ALTERATION - 4

CONSTRUCTION ORGANISATION
GELF/MADHEPURA

MASTER PLAN OF DAURAM MADHEPURA YARD AND PROPOSED SIDING TO GREEN FIELD ELECTRIC LOCO FACTORY AT MADHEPURA
(THIS DRAWING SUPERSEDES APPROVED CE' DRG. NO.-Y/51/2010)

C.E'S DRG NO: – Y – 108 – 2017 (ALT-1) (ALT-2) (ALT-3) (ALT - 4)

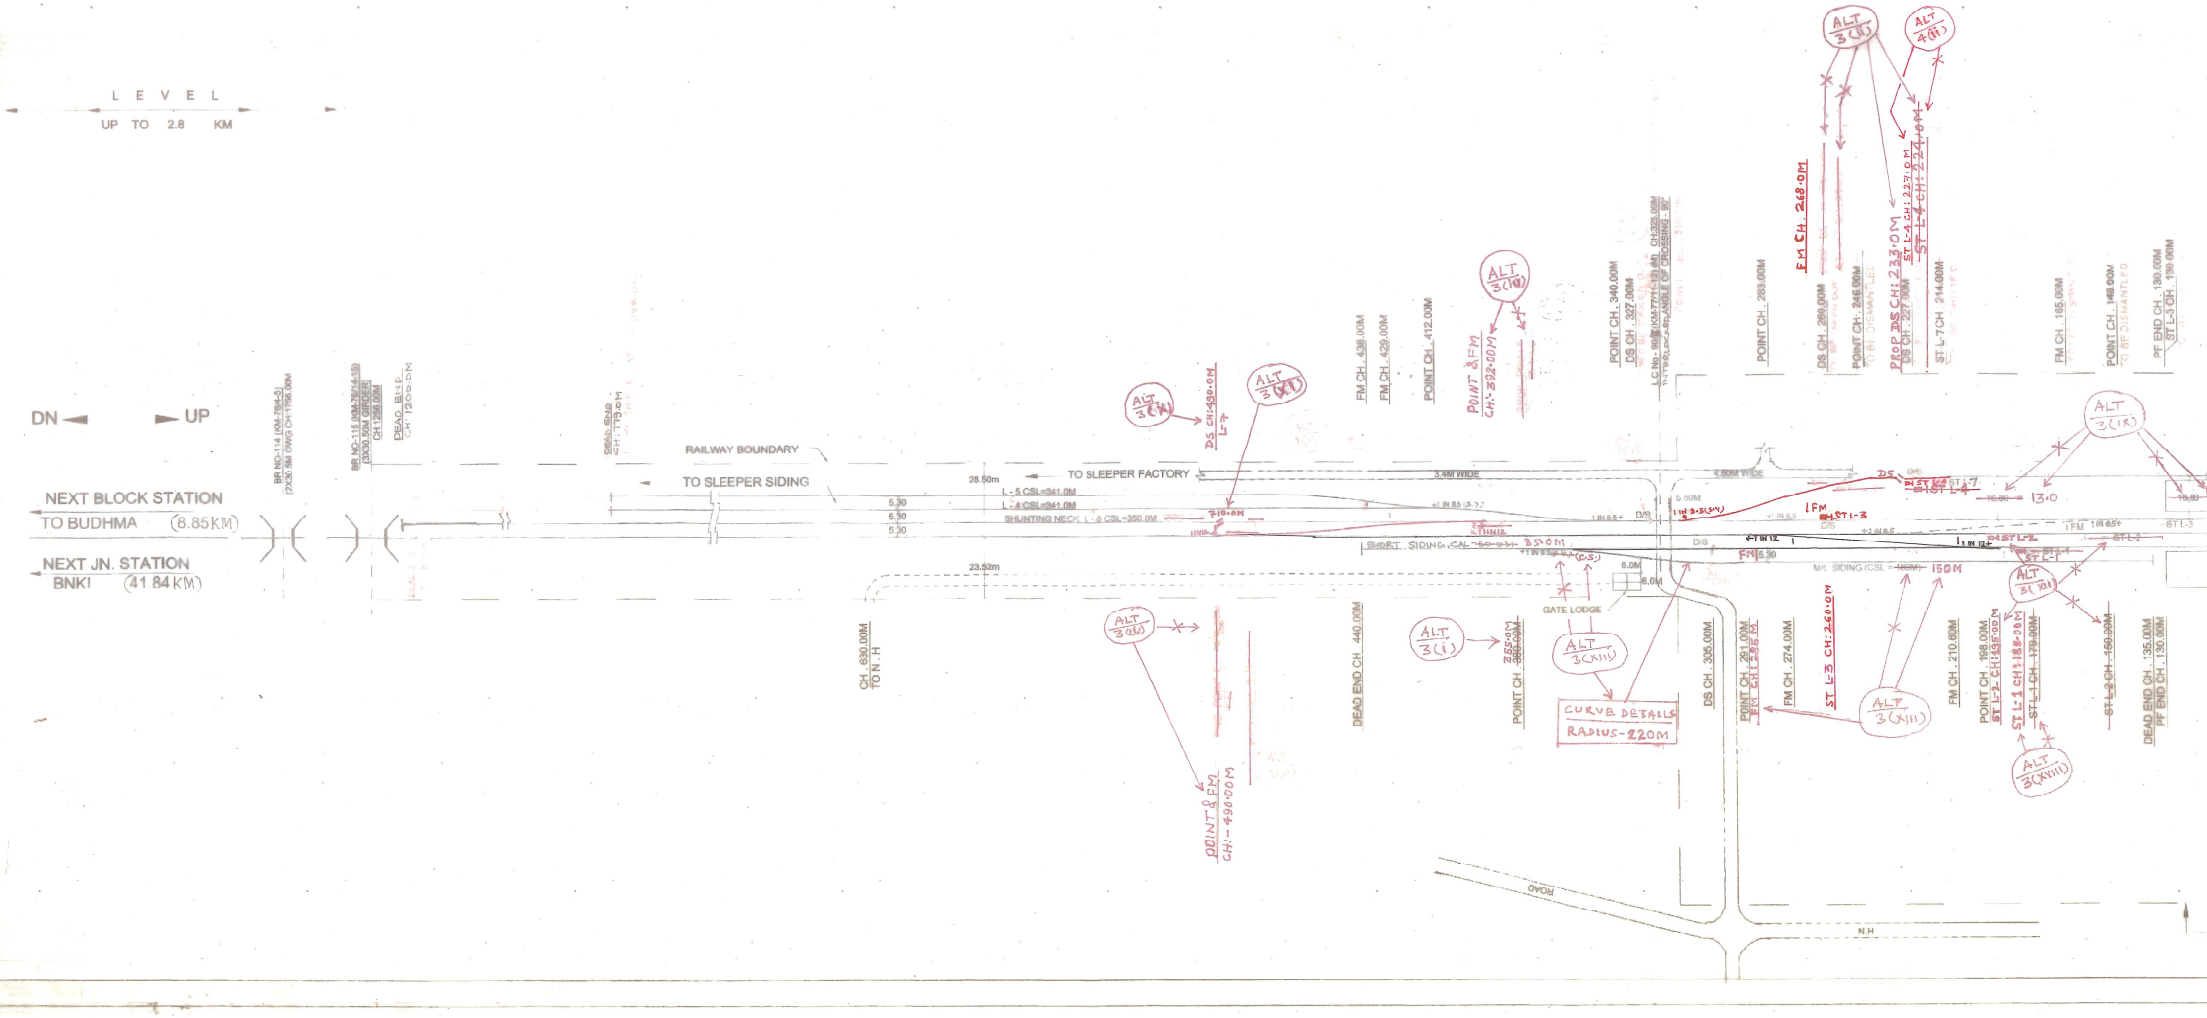
ALT NO.	DESCRIPTION OF WORK	SIGNATURE OF OFFICER
3	(i.) POINT CHAINAGE CH:380.0M TO BE CORRECTED AS CH: 355.0M ON SHORT SIDING IN BUDHMA END ALONG WITH CAL FROM 60M TO 85.0M. (ii) CHAINAGE OF PROPOSED DS AT CH: 260.0M AND ST L-4 AT CH: 256.0M TO BE CHANGE AS CH: 233.0M AND CH: 224.0M RESPECTIVELY IN BUDHMA END. (iii) CROSSOVER LINE SHOWN IN RED FROM CH: 534.0M TO CH: 589.0M IS TO BE TAKEN OUT IN BYP END AND A NEW X-OVER FROM CH: 477M TO CH: 589.0M PROPOSED. (iv) PROP. POINT & FM AT CH: 475 (L-2) AND AT CH: 377 (L-3) IS TO BE CHANGE AS CH 490 AND CH 392 RESPECTIVELY AT BDMA END. (v) PLATFORM NO 2 IS EXTENDED FROM CH: 220M TO CH: 470M AS EXISTING AT SITE SHOWN IN BLACK. PLATFORM LENGTH HAS BEEN ALSO CHANGED FROM 350.0M TO 600.0M (vi) STARTER TO BE SHIFTED ~~AT~~ FROM CH: 530.0M TO CH: 467.0M OF L-4 IN BYP END. CSL AND CAL TO BE CHANGED FROM 786M TO 691.0M AND 734M TO 710M RESPECTIVELY. (vii) FM TO BE SHIFTED FROM CH: 547M TO CH: 538.0M. (viii) LENGTH ~~OF~~ OVERRUN LINE TO BE CHANGE FROM 106M TO 162M OF L-4 IN BYP END. (ix) AS PER SITE MEASUREMENT PF. WIDTH AND TRACK CENTRE OF LINE NO. 3 & 4 HAS BEEN CORRECTED FROM 13.43M TO 9.64M AND 16.80M TO 13.0M RESPECTIVELY. (X) DS AT CH: 475.0M TO BE SHIFTED AT CH: 490M (XI) CSL OF L-7 TO BE CHANGED FROM 725M TO 710M. (XII) ST L-2 TO BE SHIFTED FROM CH: 150M TO CH: 195M IN BUDHMA END ACCORDINGLY CSL CHANGED AS 740M OF L-2	BRIJESH KUMAR SINGH (BRIJESH KR SINGH) CPDE/HJP NEERAJ AMBASTHA Digitally signed by NEERAJ AMBASTHA Date: 2021.11.02 17:18:16 +05'30' (N. AMBASTHA) CTPM/HJP 25/6/21 (C. N. SINGH) CAO/GLP 21/6/21 DRM/SPJ (ASHOK MAHESHWARI) Sr DEN/C/SPJ (RN JHA) (ASHUTOSH JHA) 21/5/2021 Sr DEE/TRD/SPJ 19/3/2021 Sr. DSTE/SPJ (RAHUL DEO) 20/05/21 Sr. DOM/SPJ (RUPESH KUMAR) 15/03/21 Sr DEN/III/SPJ (MAYANK AGRAWAL) (PRABHAT KUMAR) DY CEE/GLP (ANURAG KUMAR) DYEE/GLP 14/03/21 ADEN/SHC CUM AEN/GLP (MANOJ KUMAR)

ALT NO.	DESCRIPTION OF WORK
3	(xiii) THE FM NEED TO BE SHOWN AT CH: 285M BETWEEN MACHINE SIDING AND LINE No.1 IN BUDHMA END AND ACCORDINGLY CSL OF M/C SIDING TO BE CORRECTED AS 150M INSTEAD OF 180M. THE TERM S.Y. TO BE CHANGED AS C.S. IN THE TURNOUT 1 IN 8.5 AT CH: 355M. CURVE DETAILS ARE SHOWN. (XIV) CURVE DETAILS IS TO BE SHOWN AT CH: 1389.0 IN BYP END (XV) SPECIAL NOTE NO. 1 & 2 HAS BEEN ADDED. (XVI) CURVE DETAILS OF CURVE No. 1A AND 2A HAS BEEN SHOWN BEETWEEN THE CH: 895.3M AND CH: 1035.3M AND BEETWEEN THE CH: 645.3M AND CH: 865.3M IN BYP END RESPECTIVELY. (XVII) THE CURVE DETAILS OF TURN-IN CURVE BETWEEN THE LINE No. 3 AND 4 IS BEING SHOWN IN BYP END. (XVIII) ST L-1 AT CH: 173.00M IS TO BE SHIFTED TO CH: 188.00M IN BUDHMA END. ST L-4 IN BYP END AT CH: 529.0M IS TO BE SHIFTED TO CH: 542.0M. ACCORDINGLY CSL OF LINE NO.-1 CHANGED FROM 708.0M TO 730.0M.

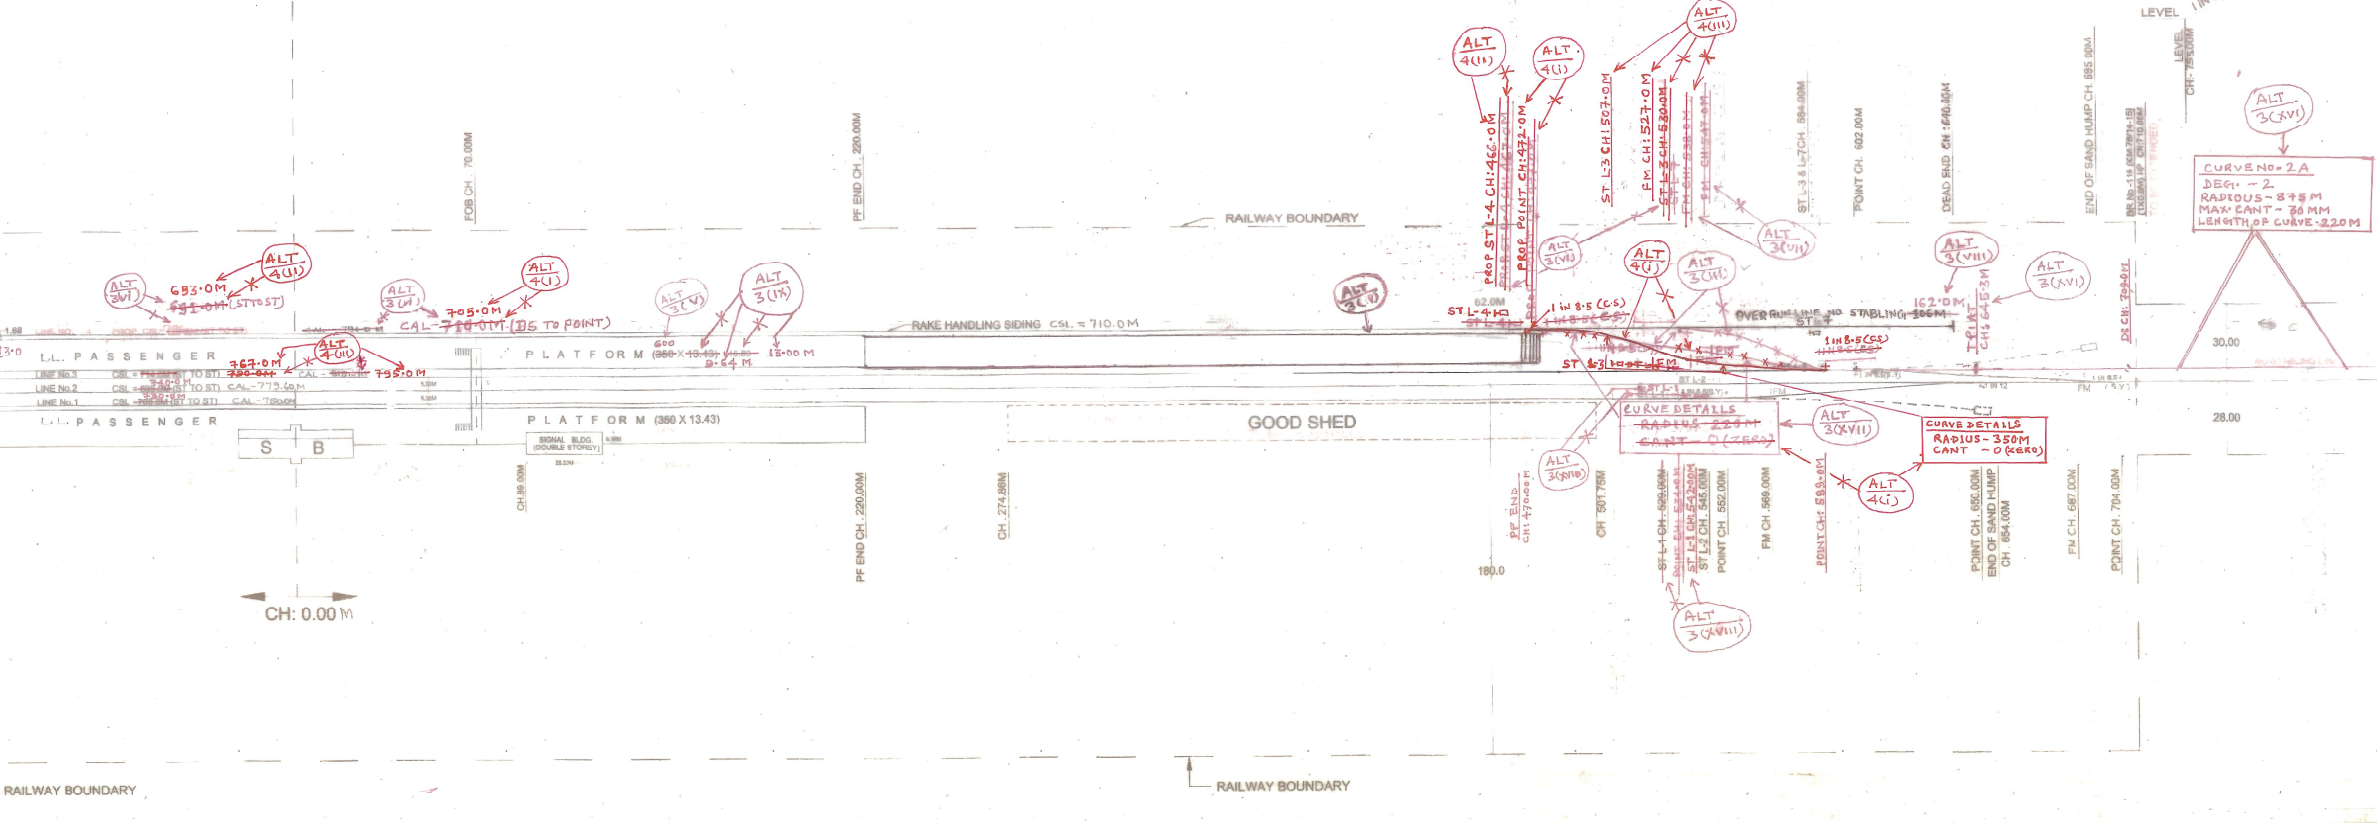
ALT NO.	DESCRIPTION OF WORK	SIGNATURE OF OFFICERS
4	FOLLOWING CHANGES IN APPROVED ESP ALT-3 IS BEING DONE. (i) CROSSOVER LINE SHOWN IN RED FROM POINT AT CH: 477.0M TO CH: 589.0M IS TO BE TAKEN OUT. POINT AT CH: 477.0M IS TO BE SHIFTED AT CH: 472.0M AND A NEW CROSSOVER 1 in 8.5 WITH CURVE RADIUS 350M IS BEING PROPOSED FROM CH: 472.0M TO CH: 589.0M IN BYP END. ACCORDINGLY CAL OF L-4 IS TO BE CHANGE FROM 710M to 705M. (ii) ST-4 TO BE SHIFTED FROM CH: 467.0M TO CH: 466.0M IN BYP END AND FROM CH: 224.0M TO CH: 227.0M IN BUDHMA END. ACCORDINGLY CSL TO BE CHANGE FROM 691.0M TO 693.0M. (iii) FM TO BE SHIFTED FROM CH: 538.0M TO CH: 527.0M. ACCORDINGLY ST L-3 TO RESHIFTED FROM CH: 530.0M TO CH: 507.0M. CSL & CAL TO BE CHANGE FROM 730.0M TO ~~8~~ 767.0M AND FROM 815.0M TO 795.0M RESPECTIVELY OF LINE No.3.	BRIJESH KUMAR SINGH Date: 2021.12.15 12:41:52 +05'30' (B. K. Singh) CE/P&D/ECR/HJP NEERAJ AMBASTHA 2021.12.10 16:43:56 +05'30' (NEERAG AMBASTHA) CTPM/HJP ANURAG KUMAR (ANURAG KUMAR) DY.CE/GELF
